**CITY OF EL PASO, TEXAS  
AGENDA ITEM  
DEPARTMENT HEAD'S SUMMARY FORM**

An Ordinance changing the zoning of Tract 4-A-1, Tract 4-A-2, Tract 4-B, Tract 4-C, Tract 4-D, Block 14, Ysleta Grant, 8100 North Loop Drive, City of El Paso, El Paso County, Texas from R-3 (Residential) to C-2 (Commercial), and imposing conditions. The penalty is as provided for in Chapter 20.24 of the El Paso City Code.

Subject Property: 8100 North Loop Drive  
Applicant: Ray Mancera, PZRZ22-00001

# 8100 North Loop Drive

## **ATTACHMENT 3**

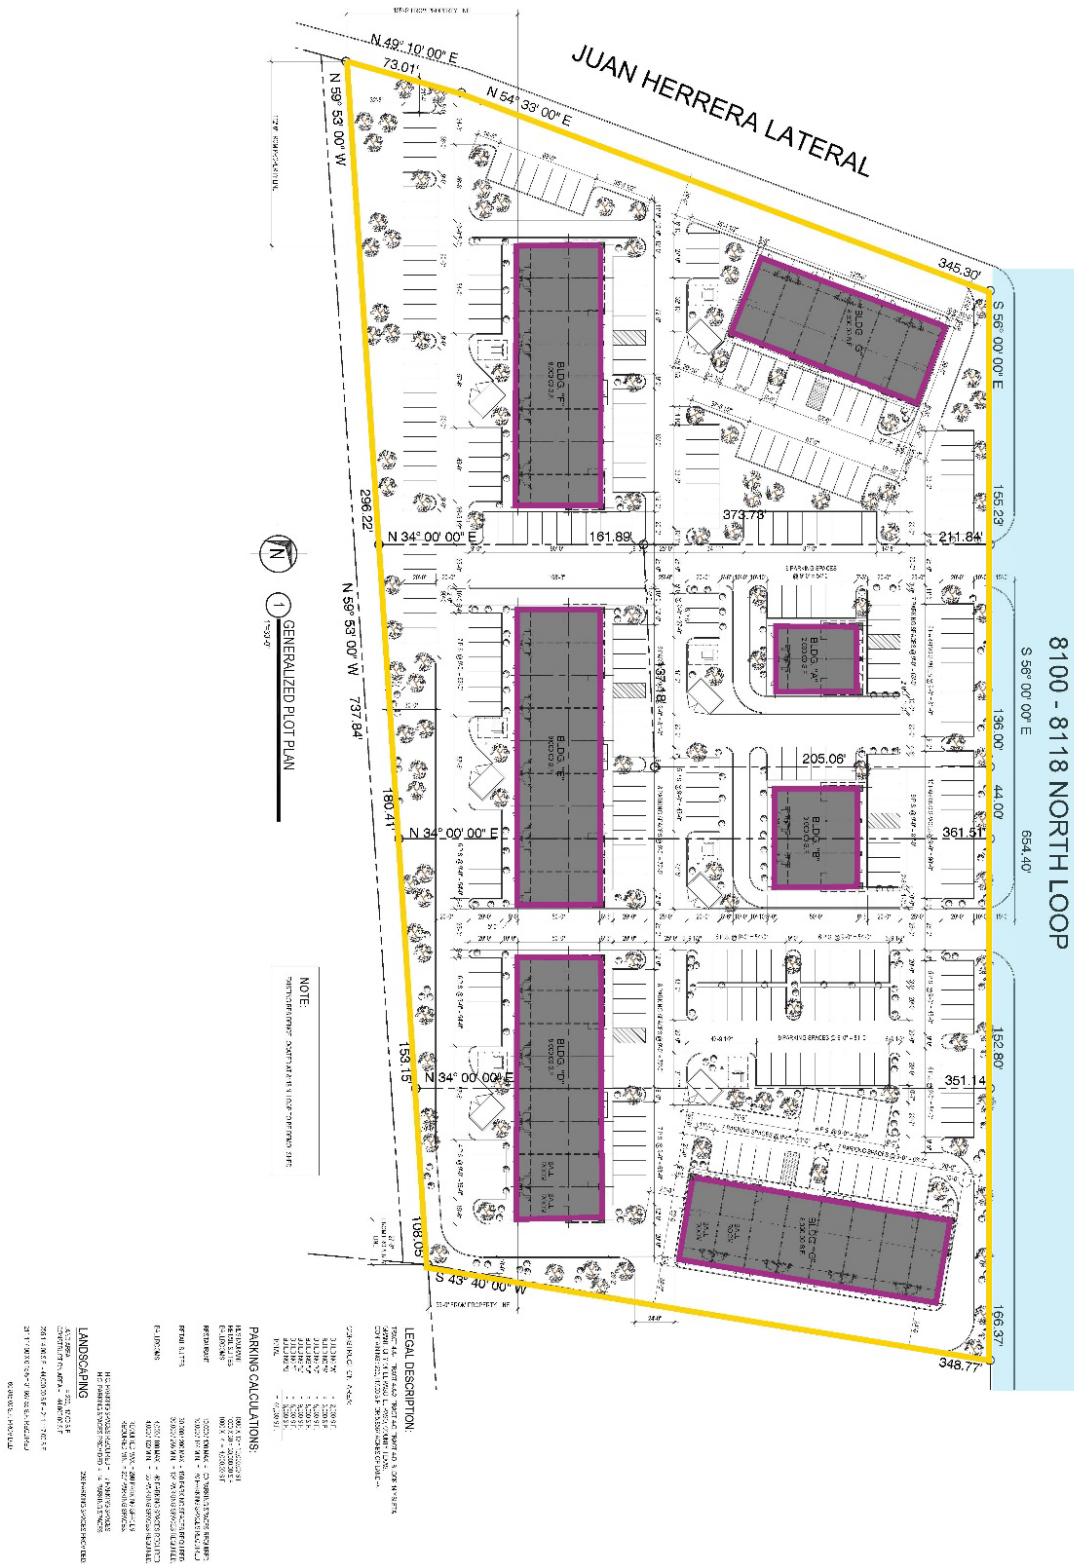
1. Staff will be recommending to provide a 10' landscape buffer along all property boundaries abutting single-family development.
2. Staff will be recommending to submit a Detailed Site Development Plan application to meet code requirements.

3. Coordinate with Streets & Maintenance Department for TIA requirements.
4. Provide a copy of articles of incorporation to define a designee or verify who can sign on behalf of the owner.

5. Show easements in the conceptual plan if any. Recommend to remove unnecessary bearings from conceptual plan.
6. Coordinate with TXDOT for improvements along North Loop.

7. Coordinate with EPCWID regarding laterals.
8. Staff will be recommending that a minimum 30-foot setback be required along the southwesterly property line and the easterly property line abutting a residential district or use.

1. The generalized site plan is not being reviewed for conformance due to conceptual nature.
2. No objections to proposed rezoning. At the time of submittal for building permit, the project will need to comply with all applicable provisions of the ICC, TAS and Municipal Code.

1. Show proposed drainage flow patterns on the site plan and identify the discharge and/or storage location(s) for all storm-water runoff within the subdivision.

2. As per Municipal Code: new developments and redevelopments are required to maintain the pre-development hydrologic response in their post-development state as nearly as practicable in order to reduce flooding. The code also encourages the use of nonstructural storm water management such as the preservation of greenspace, rainwater harvesting within landscaped areas, and other conservation efforts, to the maximum extent practicable, per Chapter 19.19, Section 19.19.010, and Subparagraph A-2 & A-5.

3. Add general note on rezoning site plan: "The retention of the difference between historic and developed storm-water runoff discharge volume is required within this subdivision's limits in compliance with all provisions of (Muni-Code 19.19.010A, DSC, and DDM Section 11.1)."

4. Coordinate with the Water Improvement District #1 for drainage and access requirements at time of building development.

TIA is required for this application.

1. Submit construction plans to ELP\_access@txdot.gov.
2. Show distances between existing and proposed driveways.
